PROTEST- PETITION

PETITION FOR TIME EXTENSION, CHANGE, TEMPORARY URGENT CHANGE OR TRANSFER ON

I (We) have carefully read the notice (state name): NOTICE OF PETITION, REQUESTING CHANGES IN WATER RIGHTS OF THE DEPARTMENT OF WATER RESOURCES AND U.S. BUREAU OF RECLAMATION FOR THE CALIFORNIA WATERFIX PROJECT, dated October 30, 2015

ON BEHALF OF: Contra Costa Water District (CCWD)

Figure 5-1. Change in Salinity due to the ELT Tidal Marsh

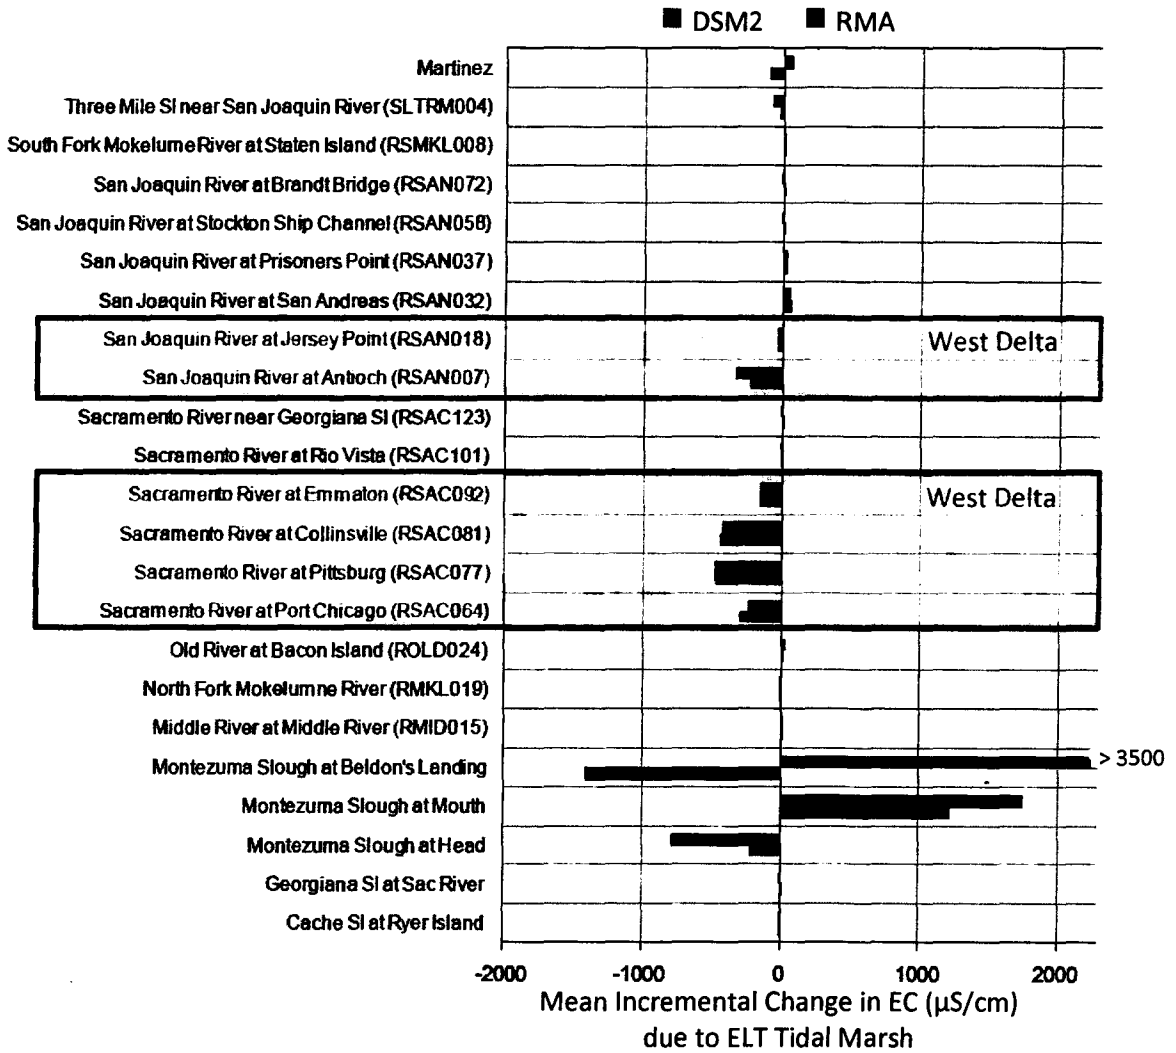
However, there is no evidence presented in the RDEIR/SDEIS to support this conclusion. To the contrary, the analysis in the 2013 BDCP Draft EIR/EIS clearly indicates that the particular configuration of tidal marsh included in the modeling *underestimates* salinity impacts, since the modeled restoration reduces salinity in the western Delta. For example, Figure 5-1 below is a reproduction of a figure from the 2013 BDCP Draft EIR/EIS that shows the incremental change in electrical conductivity (EC) due to the ELT tidal marsh configuration (25,000 acres) that was assumed in the models; the locations in the west Delta are boxed for easy identification. At every location analyzed in the west Delta, the mean incremental change in EC due to the ELT tidal marsh is negative, indicating that the incorporation of the ELT tidal marsh reduces salinity at these locations for both models that are used to simulate salinity in the Delta (i.e., DSM2 and RMA). Multiple figures in the 2013 BDCP Draft EIR/EIS illustrate that the ELT tidal marsh configuration reduces salinity in the west Delta. *See, e.g.*, 2013 BDCP Draft EIR/EIS, Appendix 5A, Section D, Attachment 2, Figures 6-26, 6-29, 6-32, 6-35, and 6-41 and Attachment 4, Figures 1-69 to 1-72.

In short, the tidal marsh assumed for the ELT reduces salinity in the west Delta. Thus, including the ELT tidal marsh in the modeling to simulate the project alternatives, when in fact the tidal marsh will not be constructed as part of the alternatives, *underestimates* the impacts to salinity in the west Delta that would be caused by the alternatives.

Figure 5-2. Monthly Average Salinity at Collinsville both with and without operation of the SMSCG

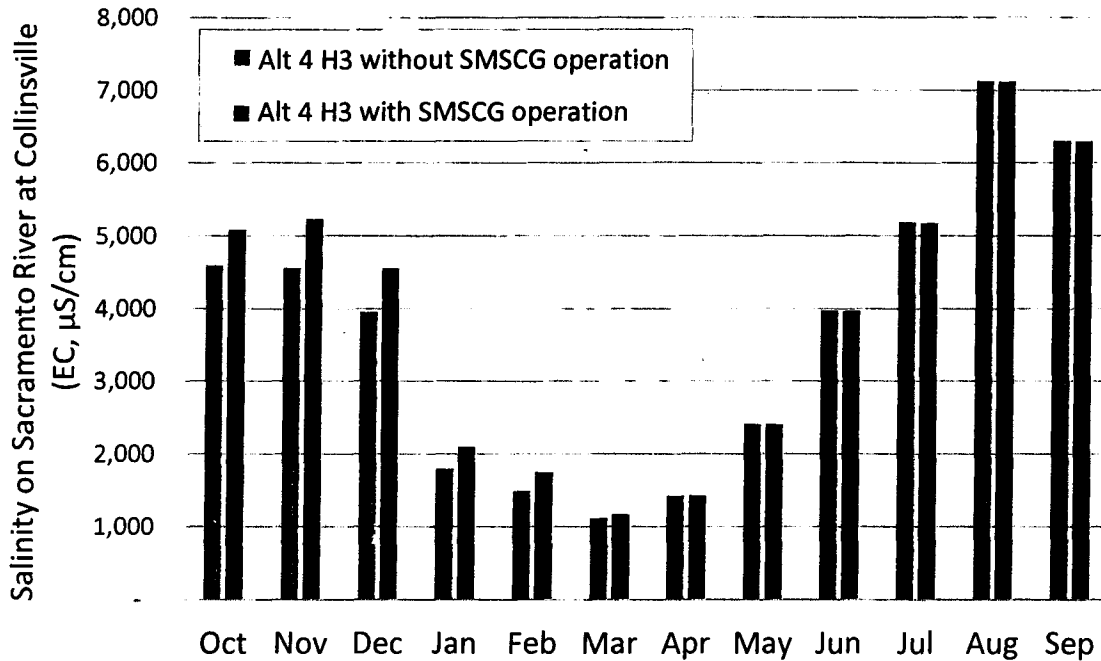
Operation of the gates creates a net flow of fresh water from the Sacramento River near Collinsville into Suisun Marsh equivalent to about 2,800 cubic feet per second (cfs), thus reducing salinity within Suisun Marsh (Enright, 2008, slide 40). The RDEIR/SDEIS contains graphs showing the reduction in salinity within Suisun Marsh in response to operation of the gates. RDEIR/SDEIS, Appendix A, Appendix 8H, Attachment 1 at p. 10 (Figures 9 and 4).

However, diversions of the freshwater into Suisun Marsh via operation of SMSCG *increase* salinity in Suisun Bay and the western Delta (Enright, 2008, slides 43 and 44). The RDEIR/SDEIS does not disclose the degradation in water quality that SMSCG operation would have within Suisun Bay or the Delta. Figure 5-2 below shows changes in salinity in the western Delta at Collinsville that are caused by SMSCG operations. The increase in salinity from October through March is an effect of project operations that is not captured by the outdated modeling that was used to evaluate water quality impacts.

Figure 5-4. HORB affects water quality in the south and central Delta, sensitivity study results

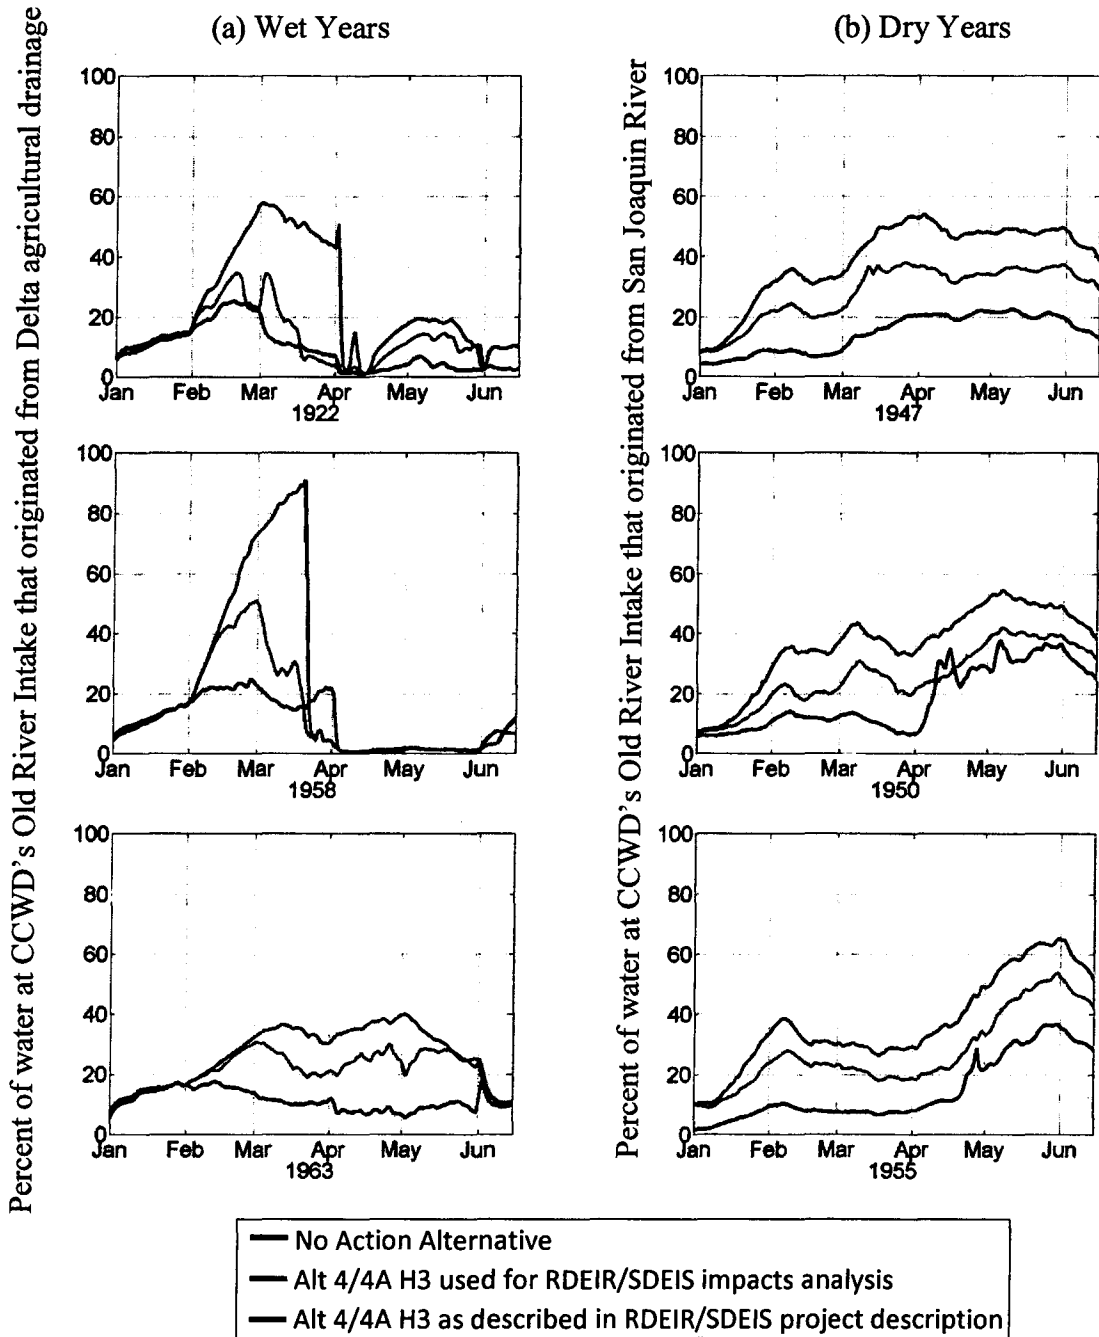
Closure of the HORB impacts the water quality in the south and central Delta; Figure 5-3 shows the geographical extent of the impacts in wet and dry years.

During dry years, the project as described in the RDEIR/SDEIS allows OMR to be negative while the HORB is closed. With no flow entering Old River from the San Joaquin River at the HORB, and with the export pumps operating, the San Joaquin River would flow north past the HORB, then turn south entering Old and Middle Rivers from the north and creating negative OMR (Figure 5-3(b)). The central Delta would receive this water heading from the north, and thus would receive a greater proportion of San Joaquin River water as compared to baseline conditions. This is an important consideration for water quality in the central Delta, since during dry years, San Joaquin River flows are generally low and the water quality is poor. Further, with the HORB closed, stagnant conditions would be created in the south Delta.

For both wet and dry years, impacts would be greater than what is modeled. In the stagnant regions, flow in the channels would oscillate with the tides, but without net flow, the residence time would be very long. (Residence time is estimated by the volume of water in a region divided by the net flow through the region, so as the net flow approaches zero, the residence time approaches infinity.) Long residence times provide optimal conditions for harmful algal blooms as discussed in Section 2.2.1.2 of CCWD's July 25, 2014 comment letter on the 2013 BDCP Draft EIR/EIS.
